RE: High Assets Assisted Living

Grading and Drainage Plan Engineer's Stamp Date: 2/16/22 Hydrology File: C13D016H

Based upon the information provided in your submittal received 2/16/22, the Grading & Drainage Plan **is not** approved Grading Permit or Final/Preliminary Plat. The following comments need to be addressed for approval of the above referenced project:

EXISTING CONDITIONS DRAINAGE PLAN

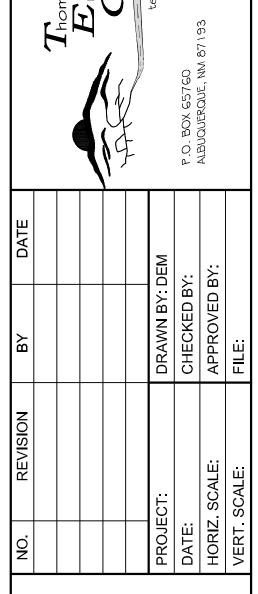
- 3. If it is phased, what will interim grading look like?
- a. Does the site need a sediment pond for the interim?4. For the basin map, please make the basin delineation larger.

- a. It does not look like the basins delineate flow do they? I would hope that is the case but it is not apparent.
 - b. Please show a water block or some delineation based on grades that show physical separation of the basins.
